**TOWN OF BROOKLYN
 PLANNING AND ZONING COMMISSION
 Regular Meeting Agenda
 Tuesday, October 20, 2020
 6:30 p.m.**

SUBJECT: Proposed Parking Expansion
Vachon Chevrolet
Assessor's Map 41, Lot Nos. 13A & 14
Providence Road (Route 6)
Brooklyn, Connecticut

ENGINEERING PLAN REVIEW PERTAINING TO A 3-LOT SUBDIVISION (ASSESSOR'S MAP 34, LOT 52) PRINCE HILL ROAD BROOKLYN, CT (September 1, 2020)

DATE: 1/07/2020	DRAWN: AMR
SCALE: 1" = 40'	DESIGN: NET
SHEET: 3 OF 5	CHK BY: ---
DWG. No: CLIENT FILE	JOB No: 19129

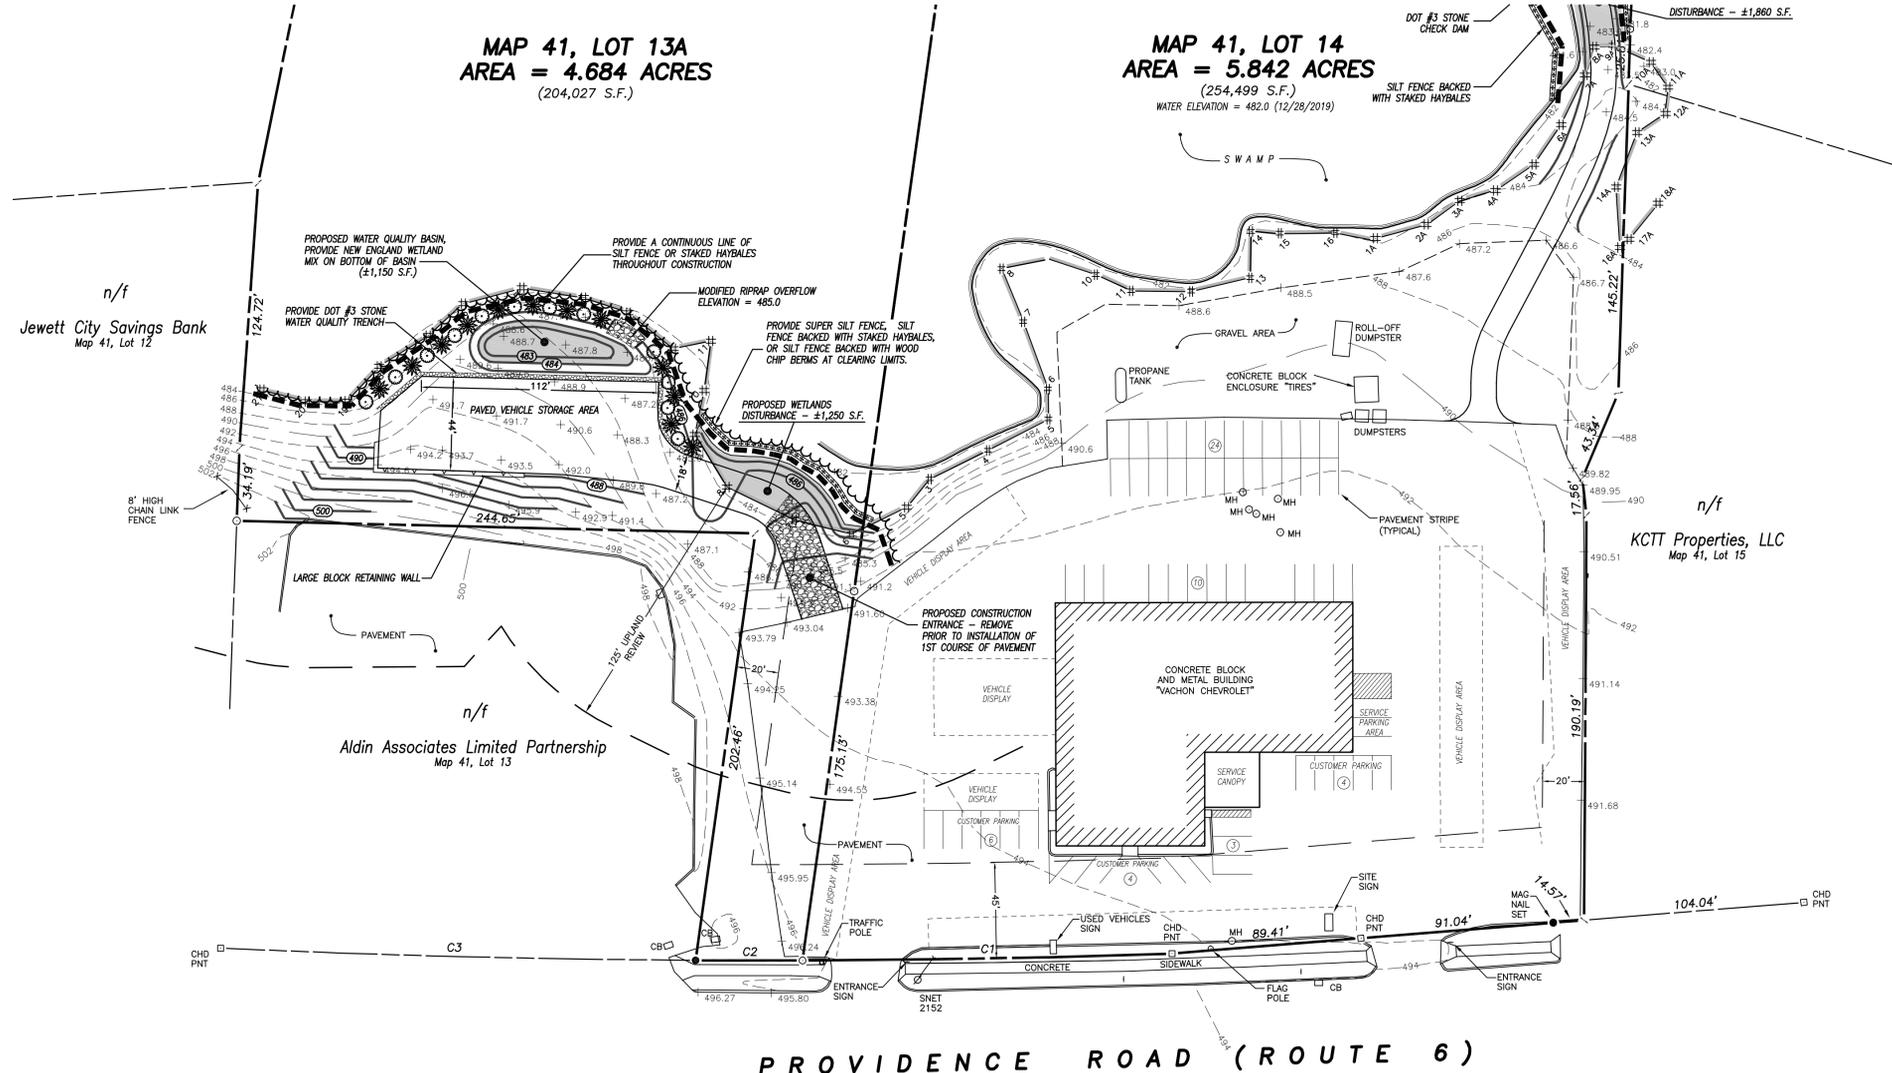
1. A construction entrance symbol is drawn at the entrance to the new "paved vehicle storage area." However, a note should be included to indicate that this will be removed at the time the first course of paving is installed for the vehicle storage area. Additionally, it would be helpful for this explanation to be included in Note 17 under "Development Schedule/Sequence of Operations" that appears on Sheet 5 of 5 of the plan set.
2. The note "Silt Fence Backed with Staked Haybales or Wood Chip Berms" should read the same as the note on Sheet 4 of 5, "Provide Super Silt Fence, Silt Fence Backed with Staked Haybales, or Silt Fence Backed with Wood Chip Berms at Clearing Limits," for consistency.

1. A note has been added to the plan to direct the contractor to remove the anti-tracking construction entrance prior to installing the first course of pavement. This has also been noted on sheet 5 of 5 in the development schedule/sequence of operations.
2. The note "silt fence backed with staked haybales or wood chip berms" has been modified to read the same on all sheets.

DATE: 1/07/2020	DRAWN: AMR
SCALE: 1" = 40'	DESIGN: NET
SHEET: 4 OF 5	CHK BY: ---
DWG. No: CLIENT FILE	JOB No: 19129

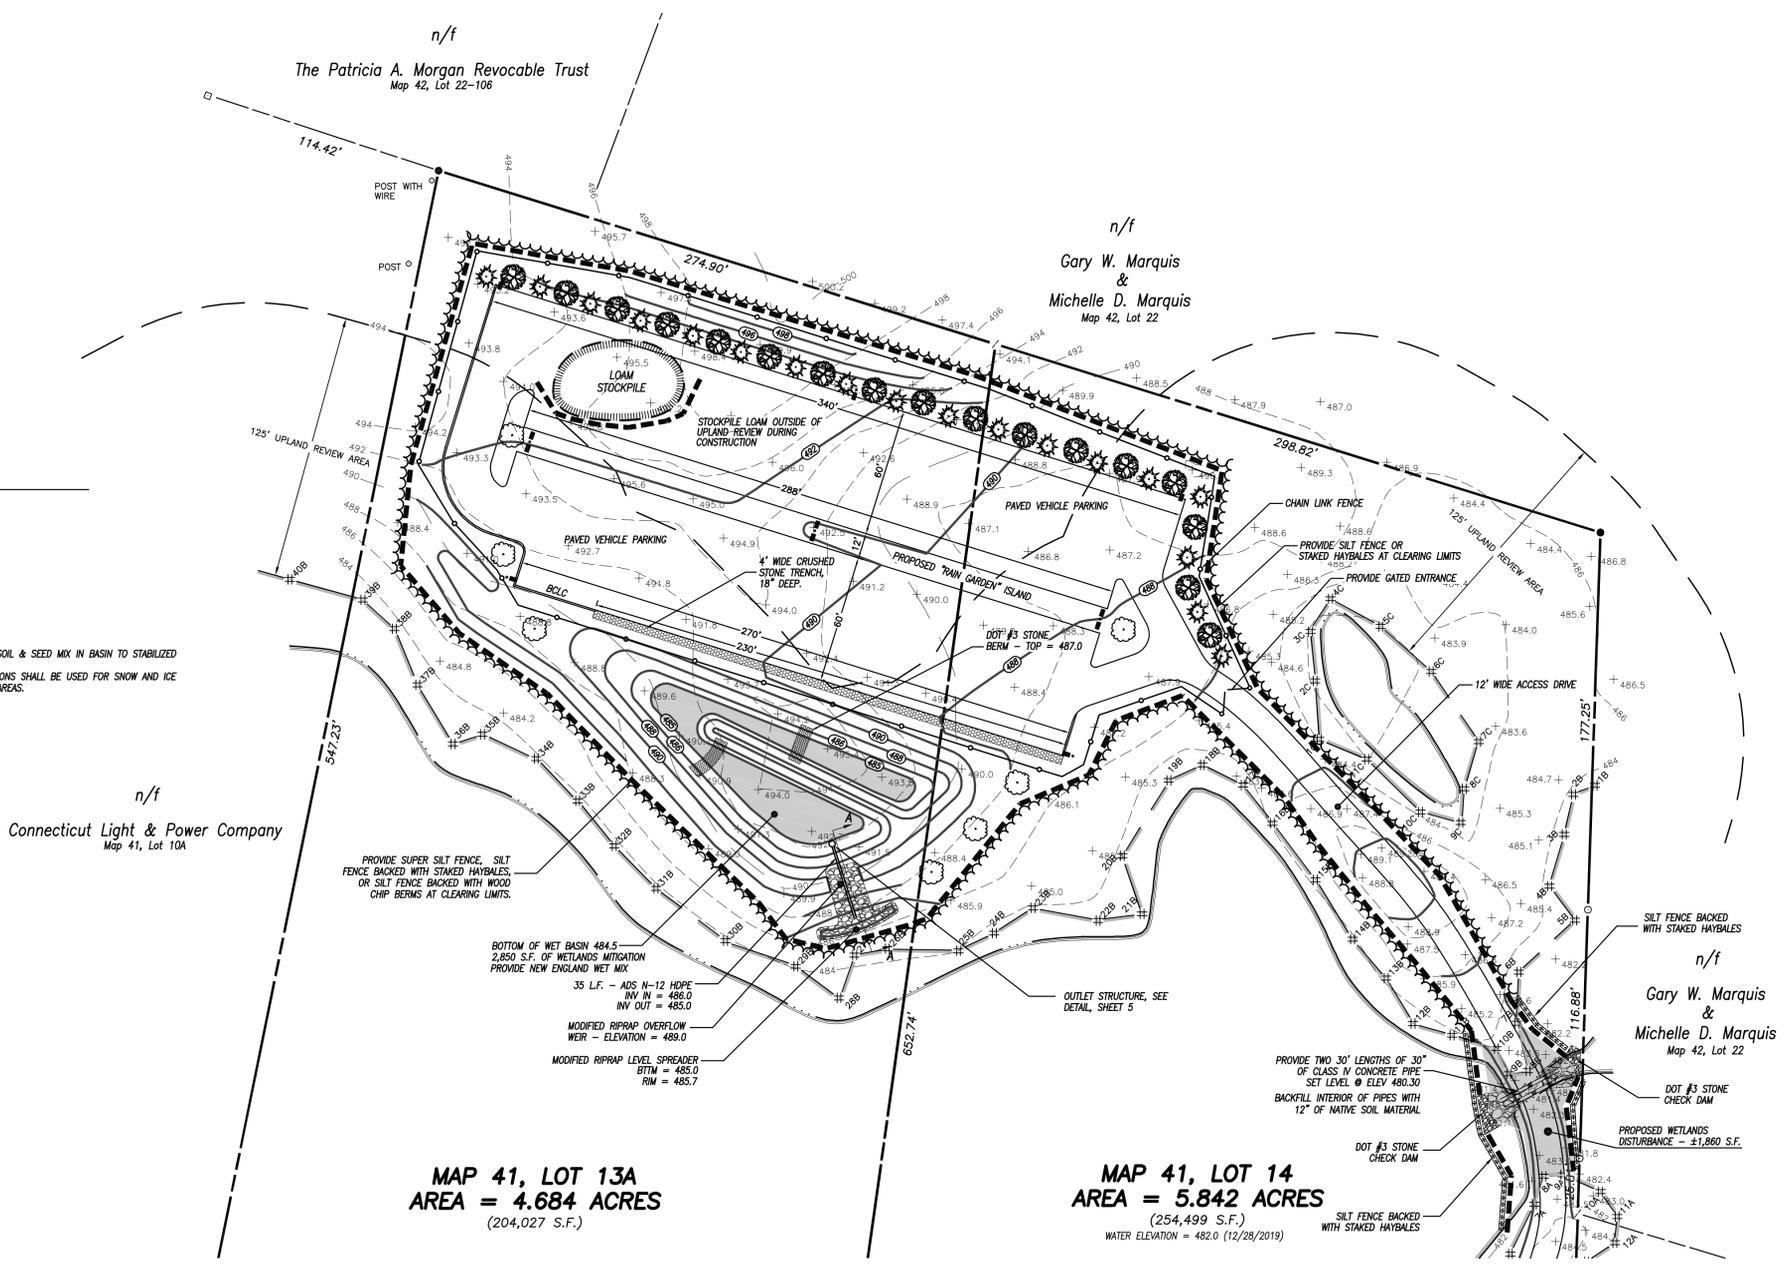
1. Proposed slopes in the detention basin range from 1:1 to 3:1. It is recommended that slope be uniform and that no slopes be steeper than 3:1 to reduce the tendency of soil erosion
2. Pedestal lighting, with dual light fixtures, is shown at three (3) locations in the middle of the proposed vehicle parking area. No description of the lighting assembly (pedestal height, pedestal base, full cutoff design, wattage, etc.) can be found in the plans under review. This is important since there is a house on adjacent Lot No. 22 that is not too distant from the north property line in the vicinity of the proposed construction on the Vachon property. It should also be noted that the

majority of the visual/sound barrier created by the existing mature forest in this area between the house and the proposed development is going to be removed, only to be replaced by young plantings that will take many years to reestablish the buffer. Therefore, has the impact of lighting and noise on the adjacent residence been evaluated to determine if there will be any significant impact to it?

3. How will snow removal be handled in this area so as not to impact the adjacent wetlands (salt or other ice removal chemicals) and proposed landscaping?
4. It is unclear on how the "island" in the middle of the proposed parking area is going to be constructed, i.e., raised island with landscaping; raised island paved with no landscaping; flush with whatever in between; etc.? Can this area be used as a rain garden to mitigate some of the runoff from the pavement?
5. Is there any consideration to provide some form of "tall" landscaping in the center island, considering how much impervious pavement is being proposed?
6. As an aid to construction, it would be helpful to include a cross-section profile from the detention basin outlet structure to just beyond the level spreader.

2. A detail for the lighting fixture with the make and model number has been added to the plans. We have also enclosed a cut sheet for the lighting as well. The chosen fixtures will be mounted no higher than 12' and are dark sky compliant. In addition, the landscaping proposed between the parking and the residences to the north will provide a very good vegetated buffer; cut sheets for the chosen plantings is included with this submission. Currently, the existing pine trees do not provide any visual buffer. As with most larger pine trees, there are minimal branches at the bottoms of the trees up to 20' or more. With regard to noise, this area will be utilized to store inventory and will not be accessed by the general public unless accompanied by a sales representative.

3. Snow will be stockpiled at the top of the slope adjacent to the proposed stormwater basin. Sheet 5 of the plans specify that no salt or chemical applications for snow removal shall be used.

4. The island in the center of the site will be depressed. We will incorporate rain garden plantings into the island to promote stormwater treatment and infiltration.
5. As the center island will be utilized in the capacity of a rain garden, we do feel that taller vegetation would be appropriate.
6. A cross section of the basin outlet has been added to the plans as requested.

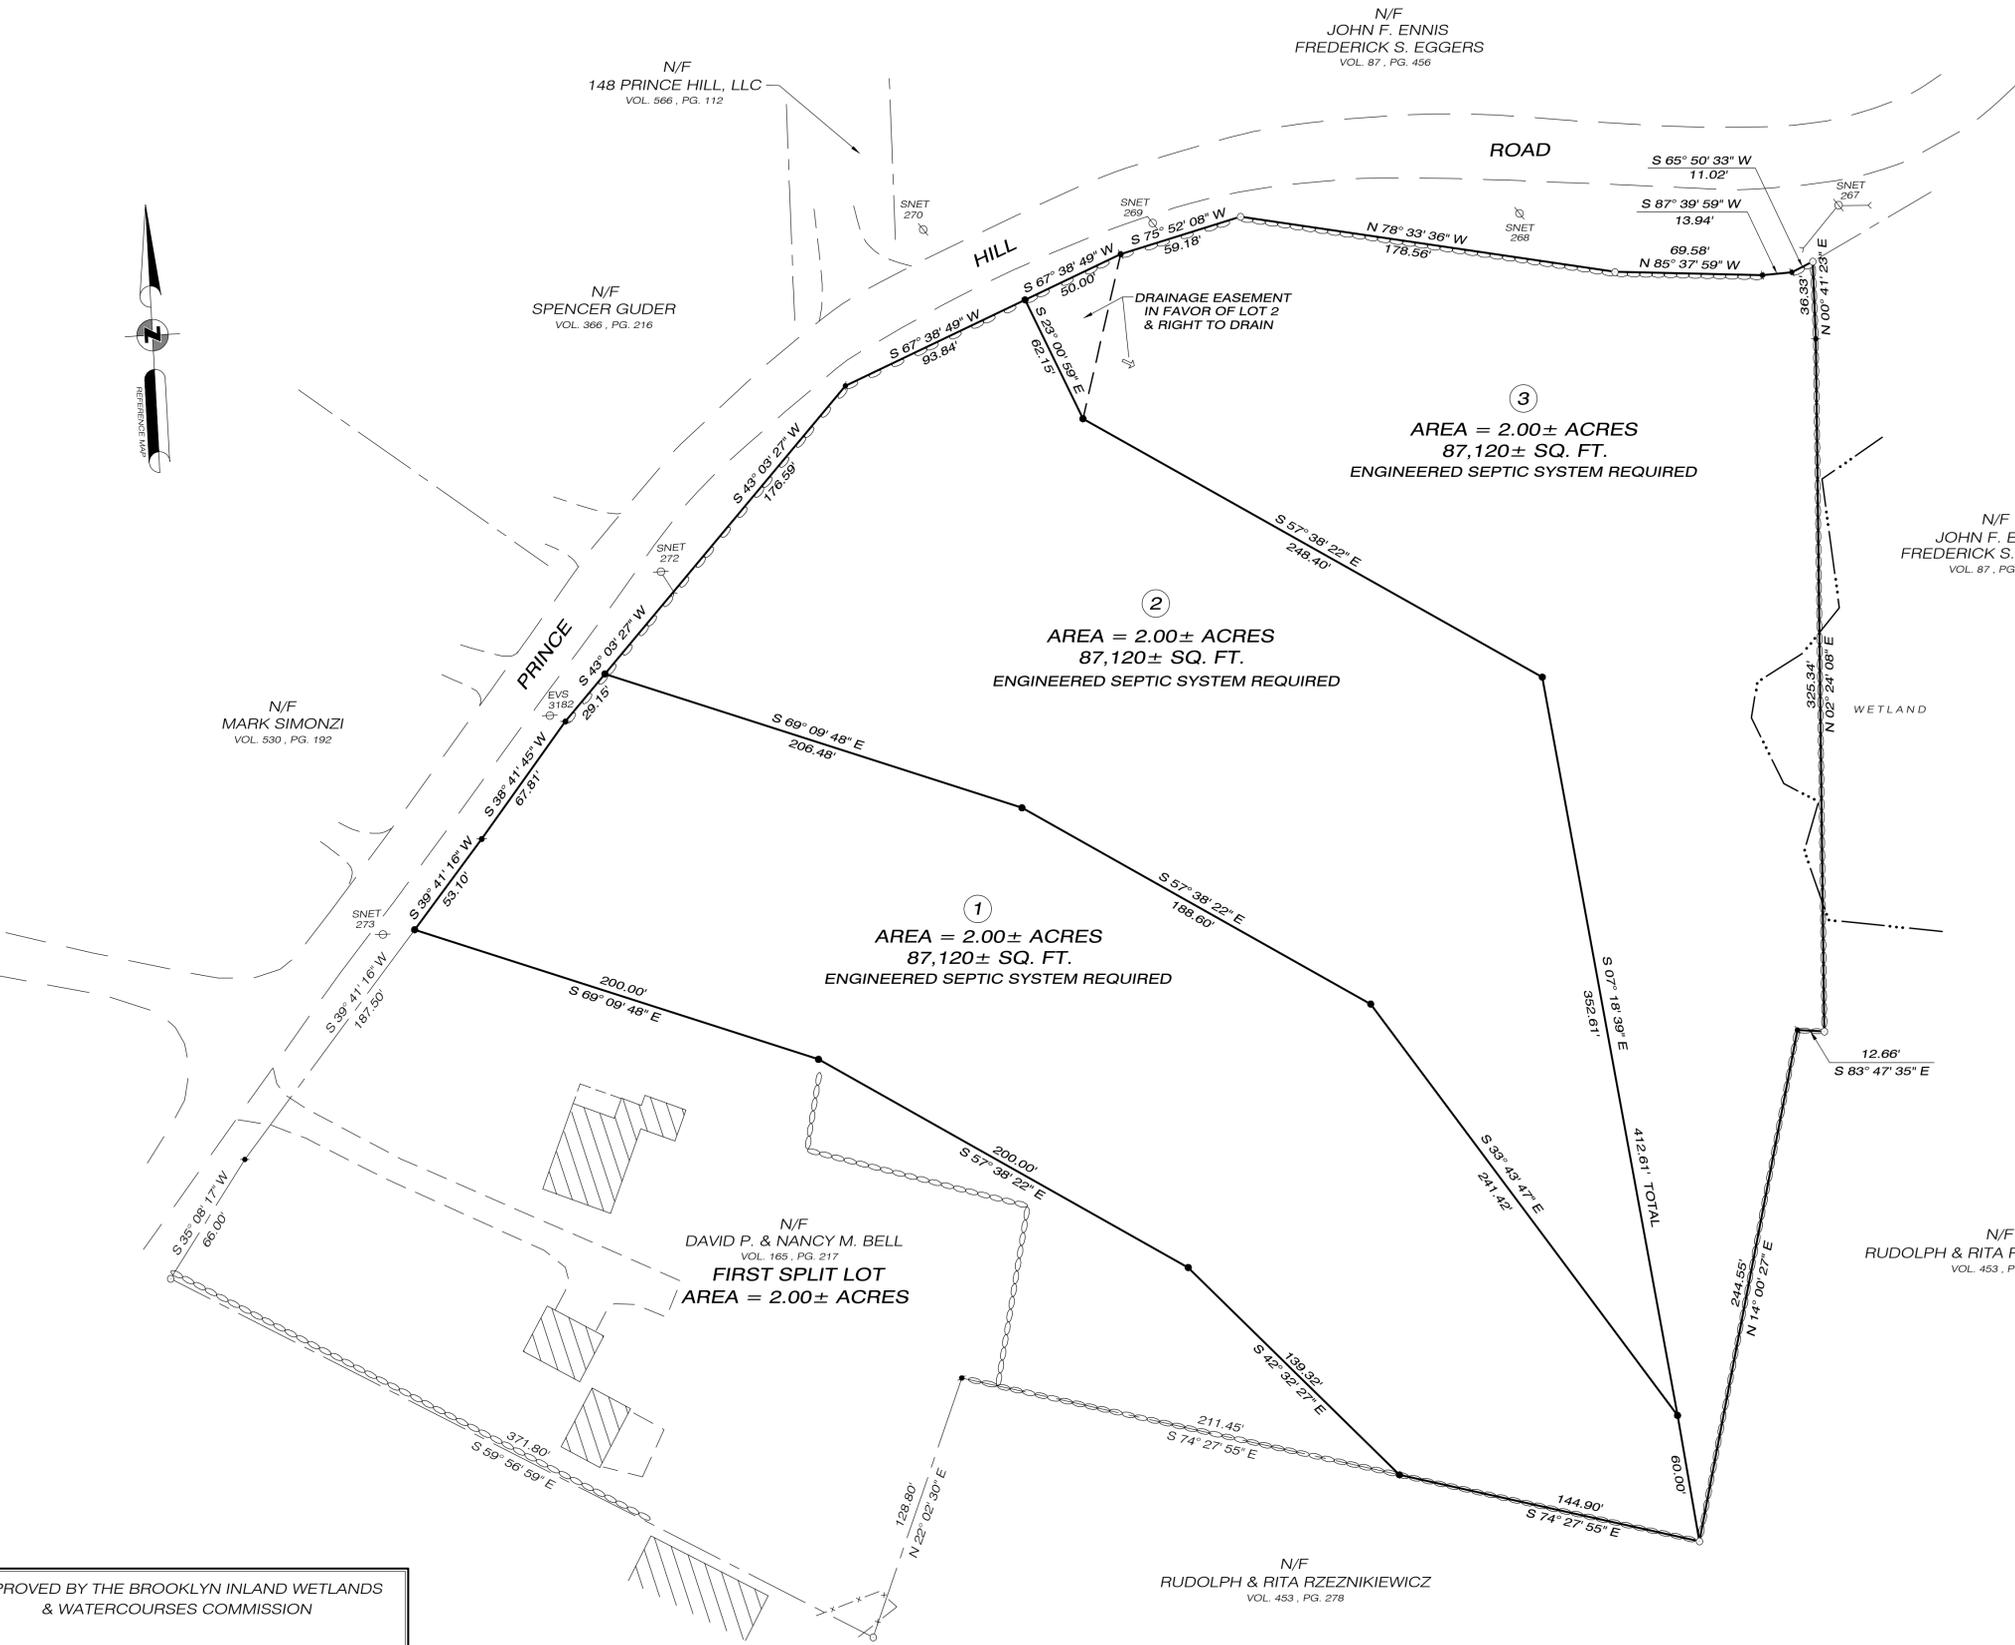
1. The Conservation Easement shown on previous plan submissions has been removed. A note on Sheet 2 of 4 of the most recent plans states that the Applicant shall pay an Open Space Fee in lieu of adding further protection to the wetland with a Conservation Easement.

2. The Sight Line Easement shown on previous plan submissions on the Subdivision Plan, Sheet 2 of 4, has been eliminated. It is my opinion that the easement is required and should be redrawn on this plan sheet and on the Lot Development Plan, Sheet 3 of 4. Incidentally, proposed grading is shown on Sheet 3 of 4 to provide a good sight line to the east for a vehicle exiting the driveway of Lot 2 and motorists traveling eastbound on Prince Hill Road.
